**GREATER NEW HAVEN WATER POLLUTION CONTROL AUTHORITY  
CWF 2017-01 CAPACITY UPGRADES AT EAST STREET PUMP STATION  
FOR CSO REDUCTION  
ADDENDUM NO. 1**

**GREATER NEW HAVEN WATER POLLUTION CONTROL AUTHORITY  
CWF 2017-01 CAPACITY UPGRADE AT EAST STREET PUMP STATION  
FOR CSO REDUCTION  
Pre-Bid Conference Agenda**

JUNCTION CHAMBER EQUIPMENT AND PIPING PLAN AND SECTION

DRAWING NO.: M-401

SHEET TITLE:

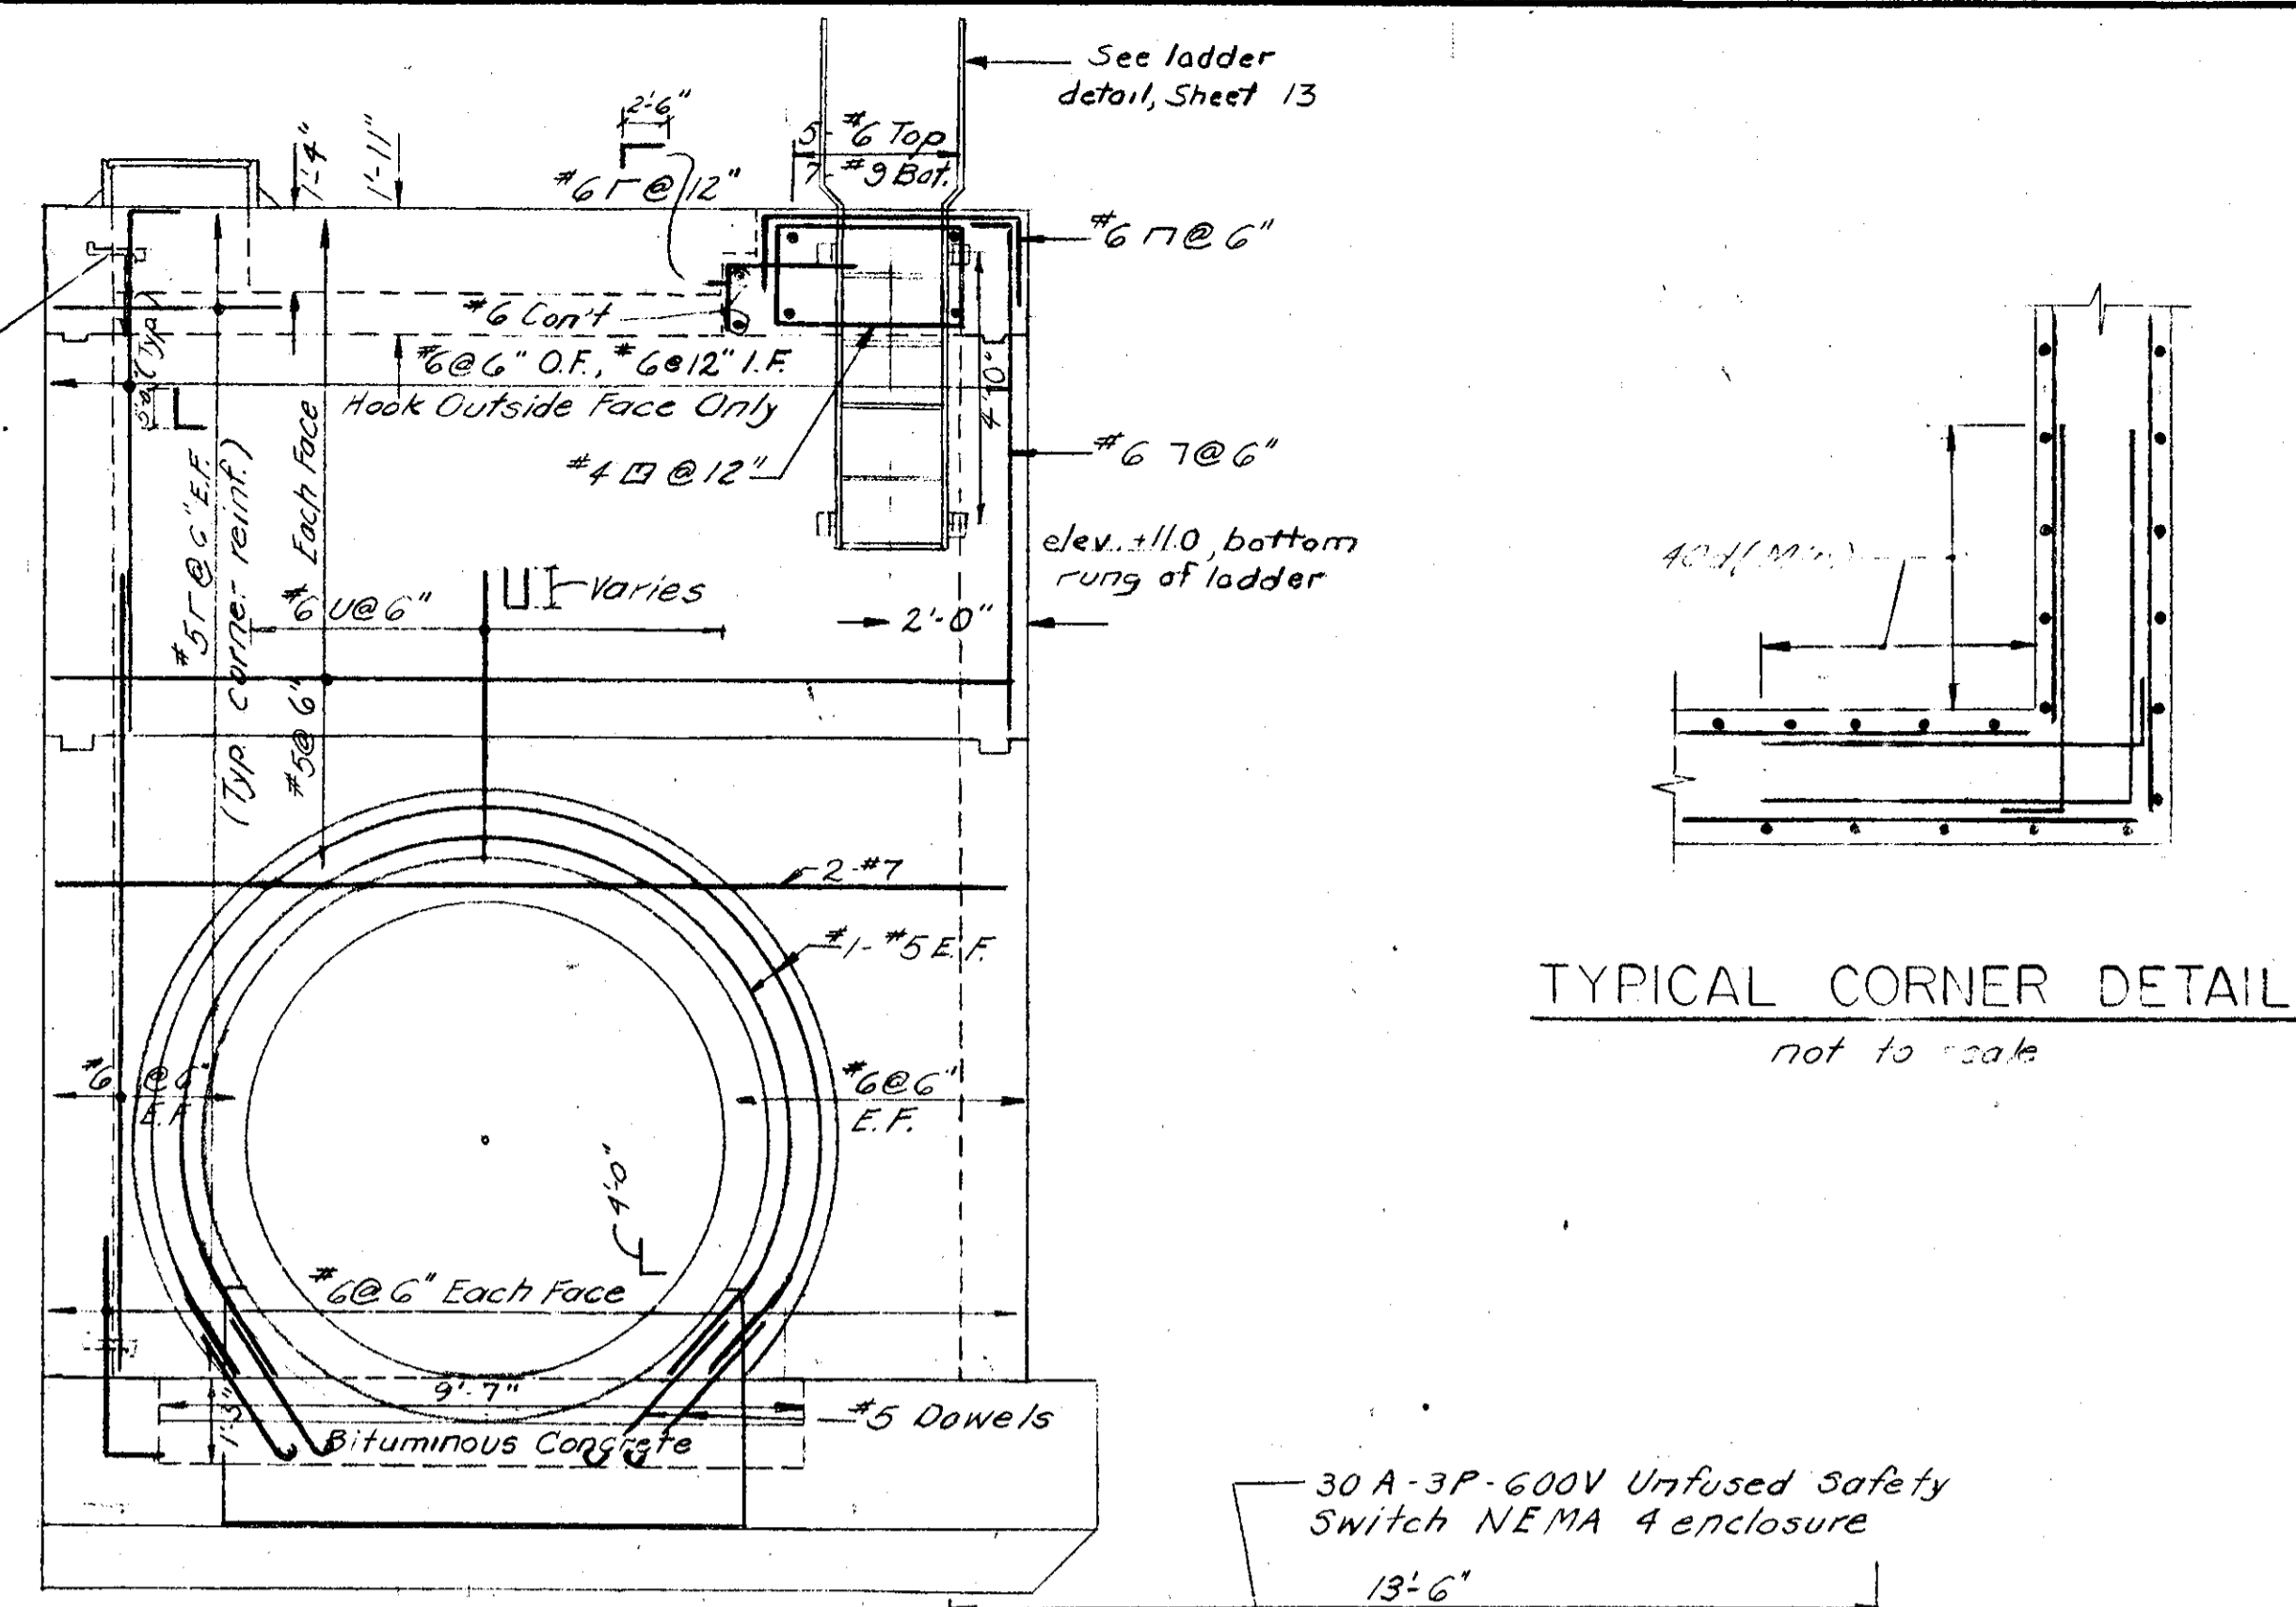
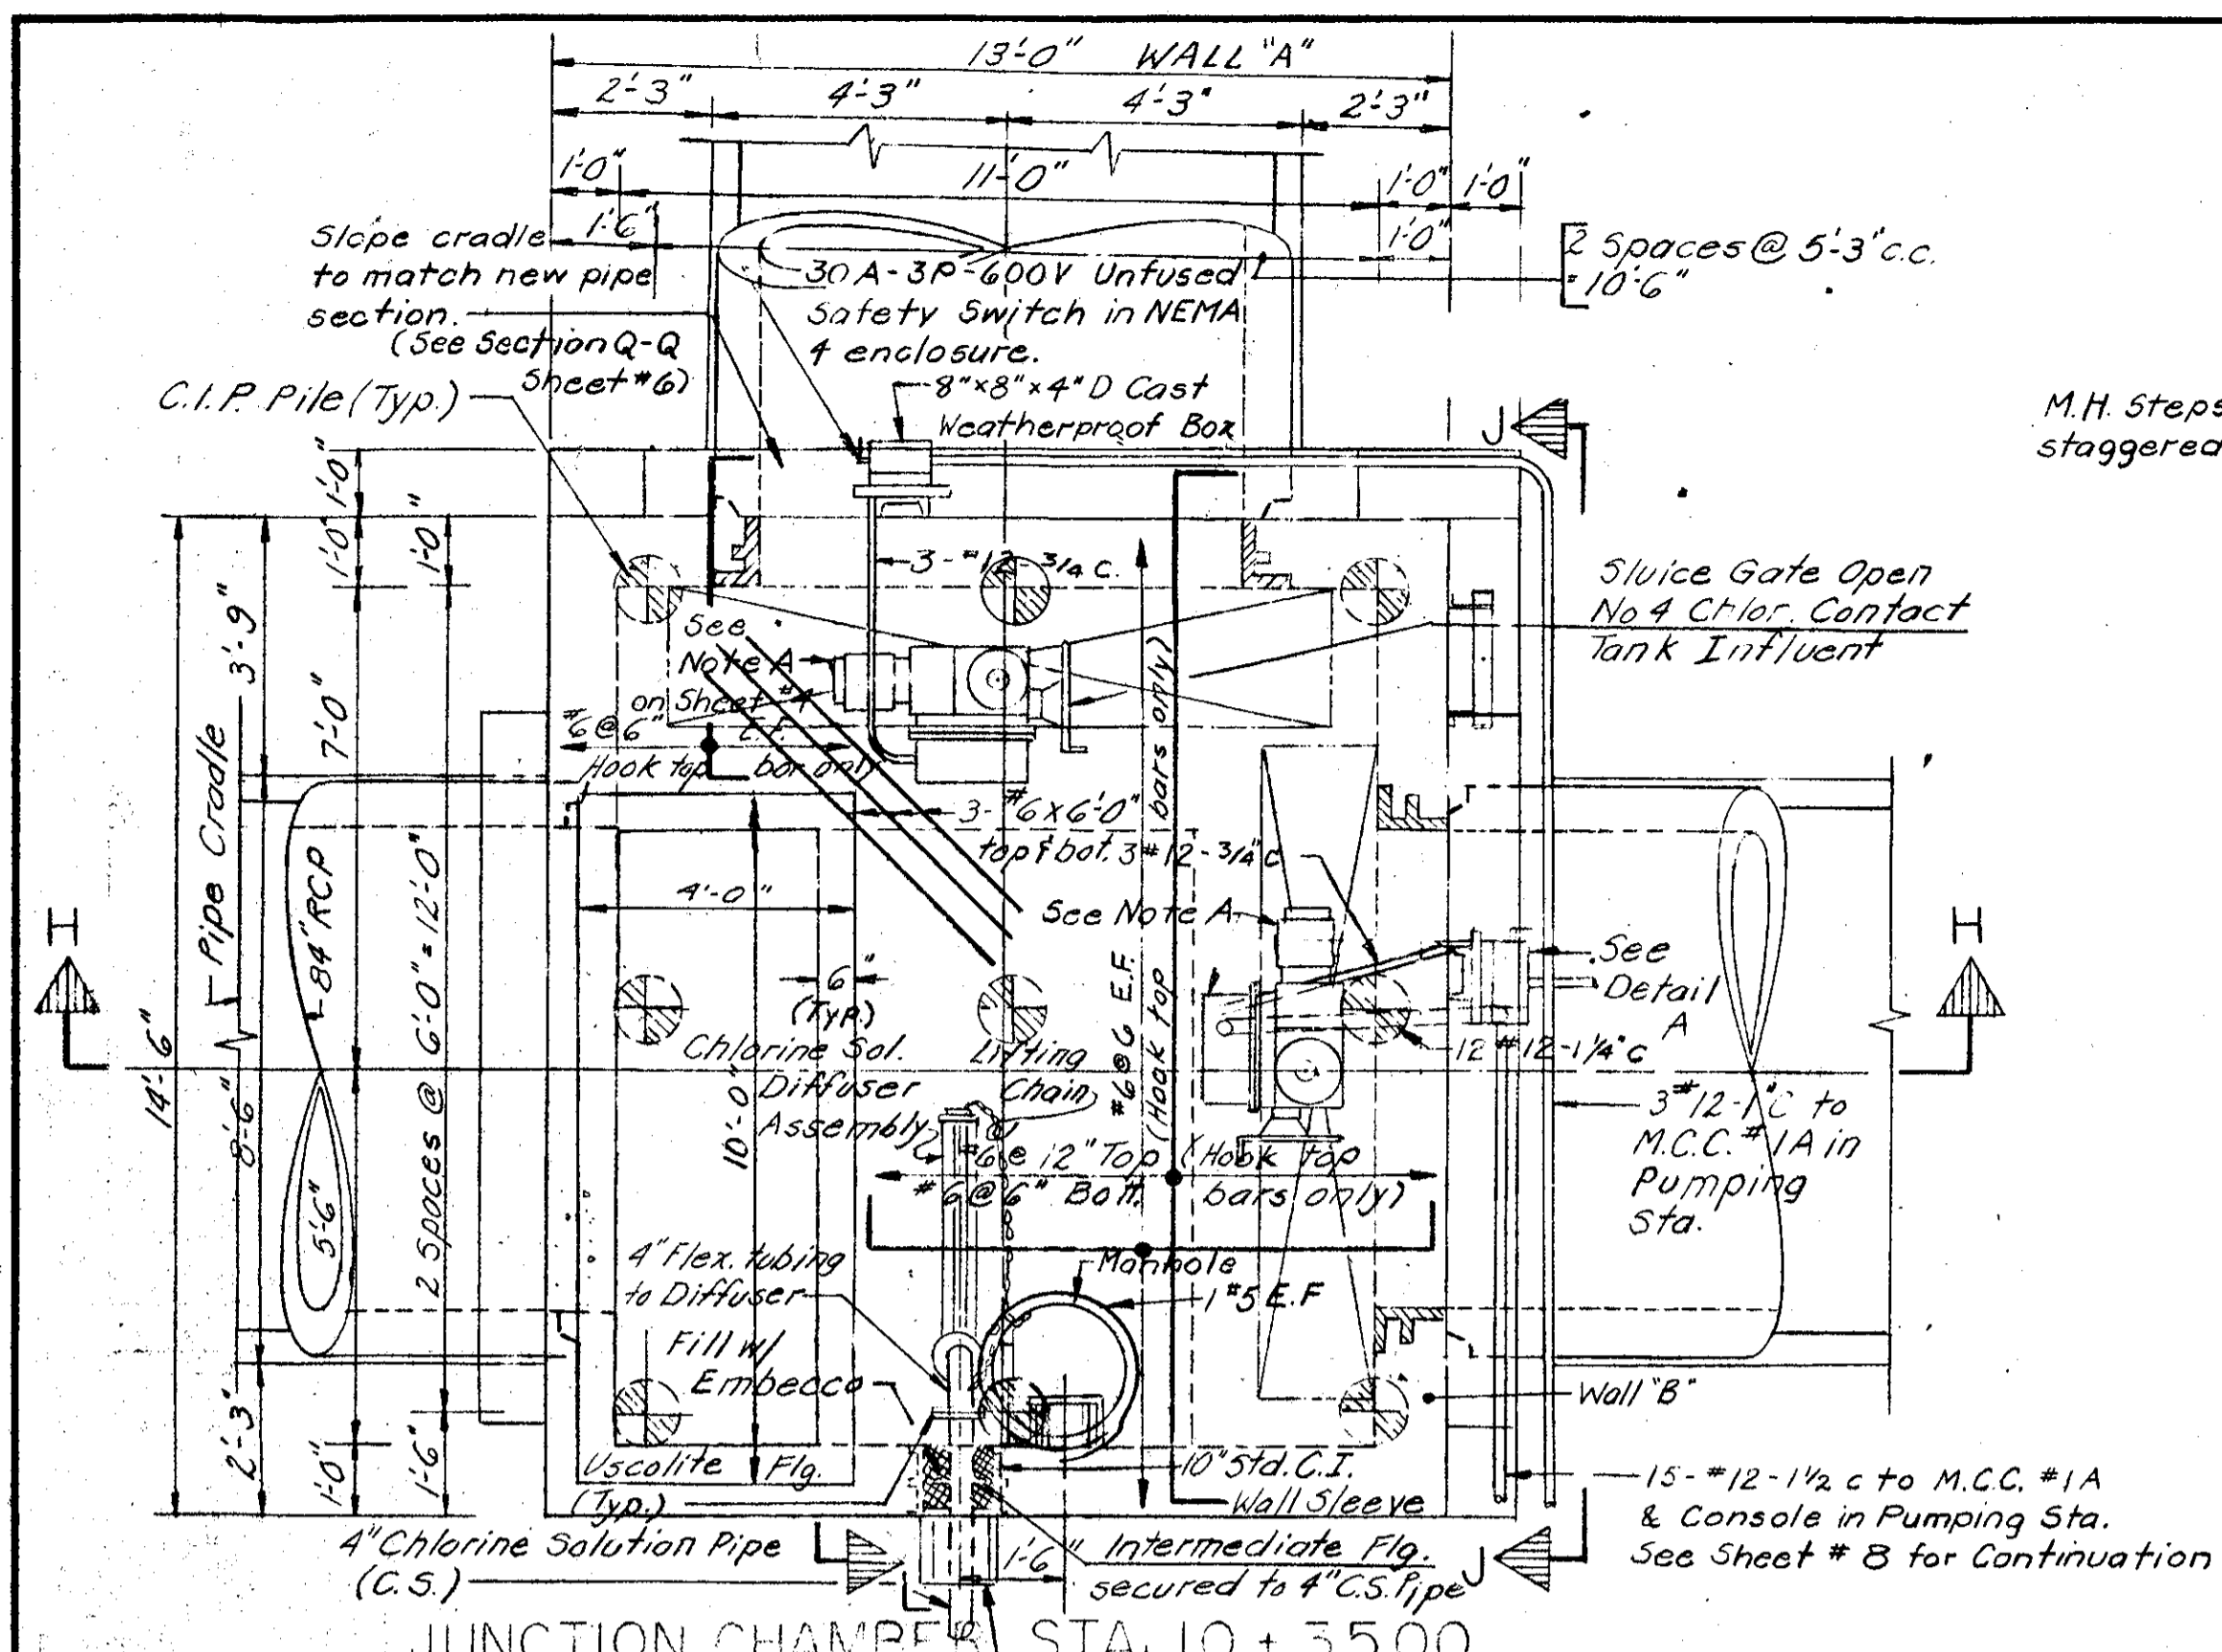
12. Question: Drawing C-101 – Are record drawings of the influent junction chamber available? We are trying to determine if this structure is pile supported.

Response: Available record drawing is provided for reference.
